Zoning & Planning Committee **Report**

City of Newton **In City Council**

Wednesday, December 11, 2019

Attachment A – Suggested Change Log

Attachment A – Suggested Change Log

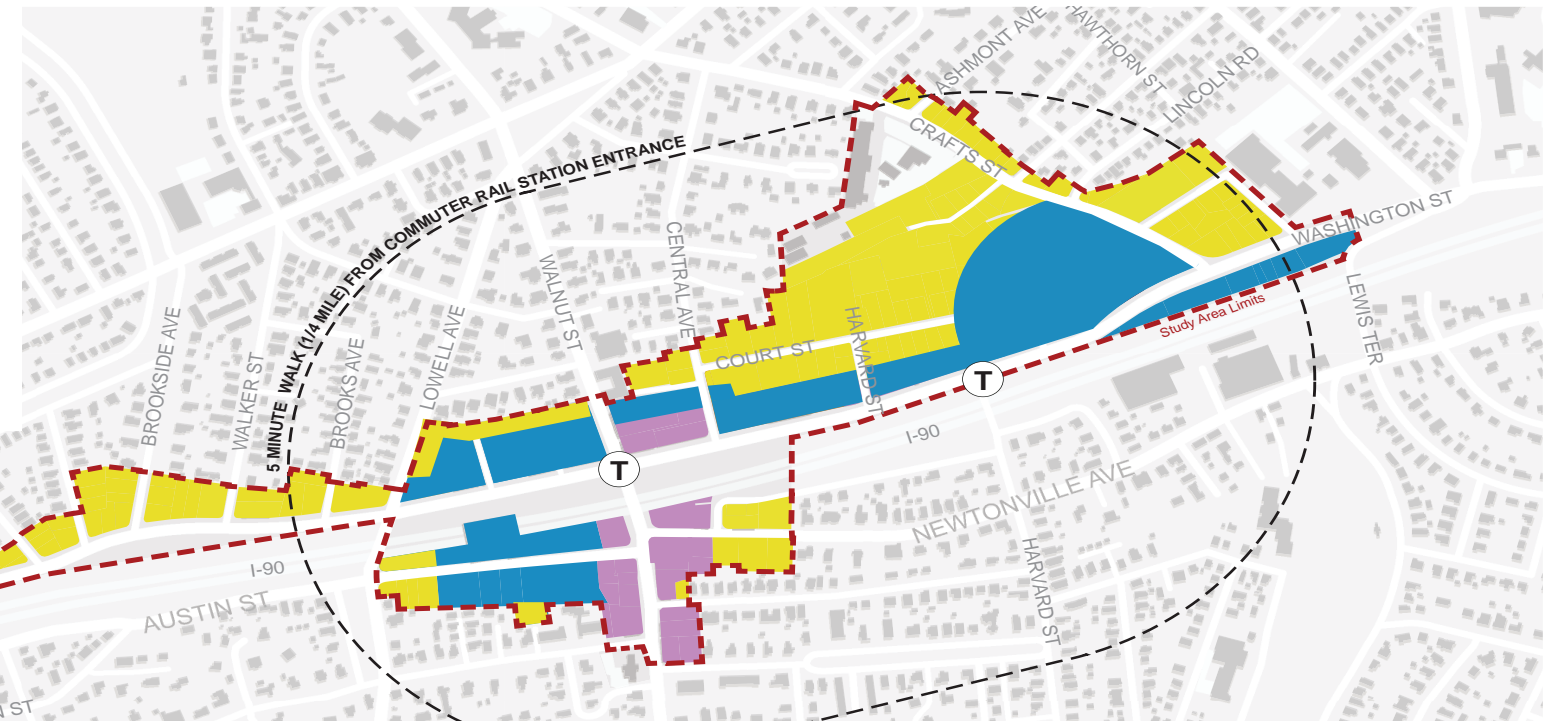
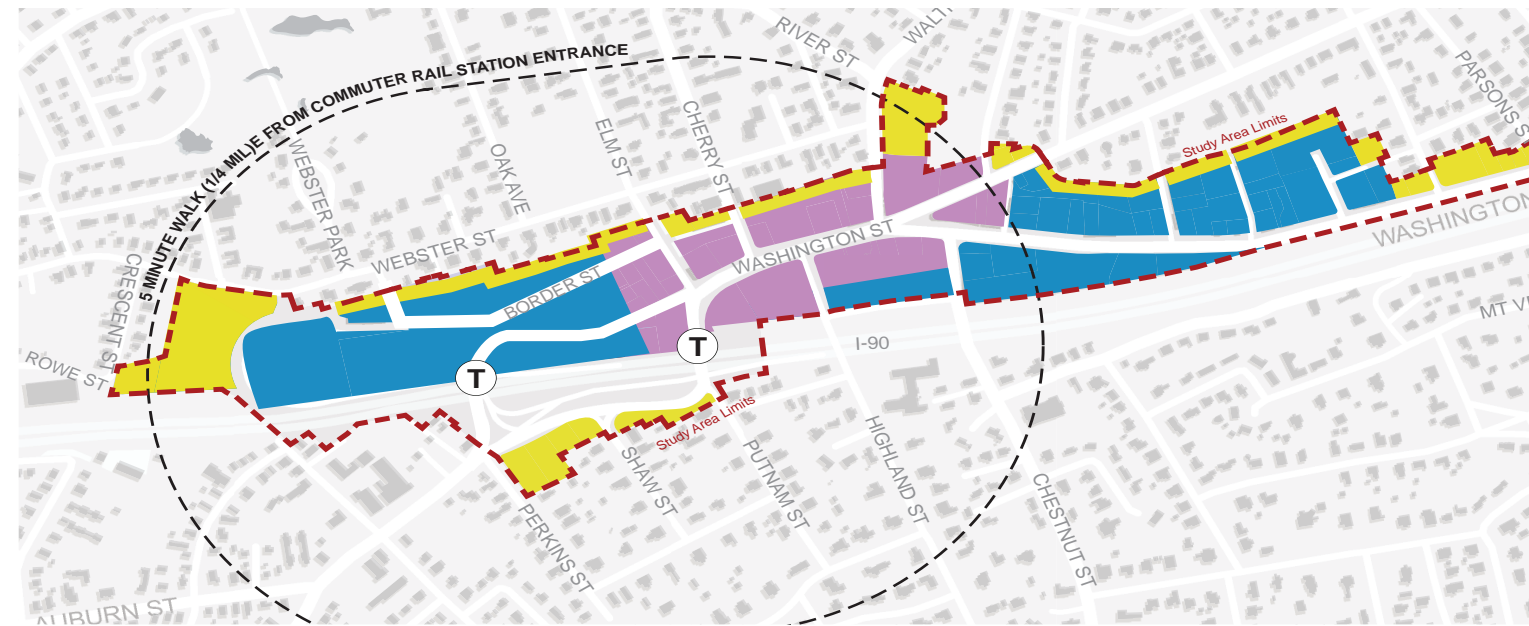
Pg.	Existing	Proposed
30	...and additional spaces on the edges for bikeways and parking.	...and additional spaces on the edges for bikeways and parking. At the same time, such a boulevard design also has to provide opportunities for short-term parking, drop off/pick up, and deliveries.
47	Newton should consider removing the minimum parking requirement entirely.	Newton should consider reducing or eliminating the parking minimum requirement.
53	New zoning for Washington Street can ensure that the building types allowed in each portion of the corridor are contextually appropriate and support the goal for diversity in housing.	New zoning for Washington Street can ensure that the building types allowed in each portion of the corridor are contextually appropriate and support the goal for diversity in housing, including ownership and rental products as appropriate.
55	...diverse and affordable housing throughout the Washington Street area to maintain economic diversity in these neighborhoods.	...diverse and affordable housing throughout the Washington Street area to maintain economic diversity in these neighborhoods. In addition the City of Newton should encourage and support diverse and affordable housing throughout all the Villages of the City.

63	Smaller units can additionally address the city's needs for a greater housing diversity.	Smaller units can additionally address the city's needs for a greater housing diversity, and by virtue of their size, even market rate units may be more affordable.
70	Captain Ryan Park in West Newton could be redeveloped as a more vibrant community space.	Captain Ryan Park in West Newton should remain as open space and improvements should be made to make it a more vibrant community space.
86	...buildings with varying heights, materials, and other design distinctiveness.	...buildings with varying heights, materials, and other design distinctiveness. In addition many of the most iconic buildings are historic, meaning new development may want to draw upon such historic elements.

This diagram illustrates the height principles along Washington Street. The height ranges shown correspond to the area-wide planning principles:

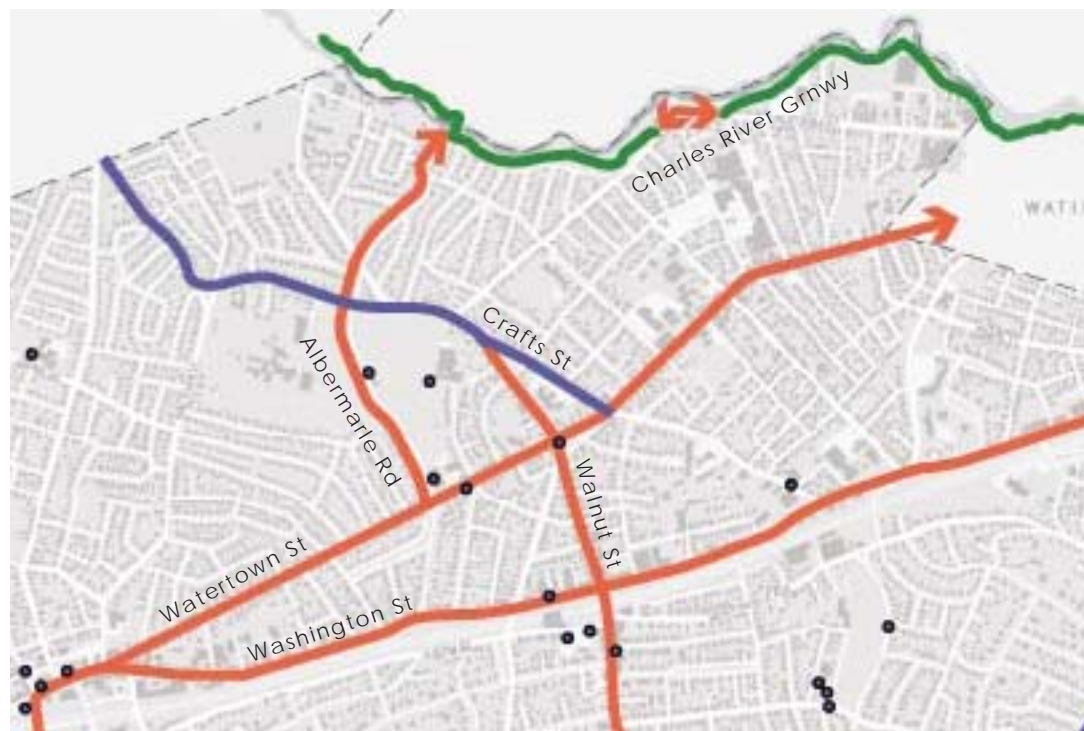
* The map that now shows detail of Webster st includes shading which indicates that the 3-6 stories would be applicable to a portion of Webster St. I would like to see this removed as you now would have the potential for a 6 story building across the street from a single family home(s). Easiest way to do this is to eliminate anything west of the streets that provide access to the T parking lot. The whole Border St area is not Washington St so reducing that further makes sense to me. The parking lot is the parking lot, but there is housing right up against Border st and I think this is a different area for zoning.

Concerns were raised regarding the maximum height of 6 stories as well as location and number of areas identified as medium height (3 to 6 stories) and whether the maximum 6 stories would be permitted in all of these areas. The current draft of the Plan includes a Height Principles Diagram, which includes three different sets of height ranges: low heights – neighborhood character (1 to 3 stories); low heights – village character (1 to 4 stories); and medium heights – village character (3 to 6 stories). Voted on by the committee previously, these height ranges represent a reduction in height as proposed in previous drafts where up to 10 stories was proposed as of right. This draft

Numerous iterations of the height map within the Plan has led to the current version. It must be noted the height map is an illustration, not a regulatory zoning map. Updates to the current version include the additional labeling of streets and the reduction of the westernmost portion of the study area from “medium height” to “low height – neighborhood character”.

Councilor Downs motioned to lower the heights of the buildings on the western edge of the project in the map and to put on the names of the streets. The Committee voted 7-0 in favor of the map changes.
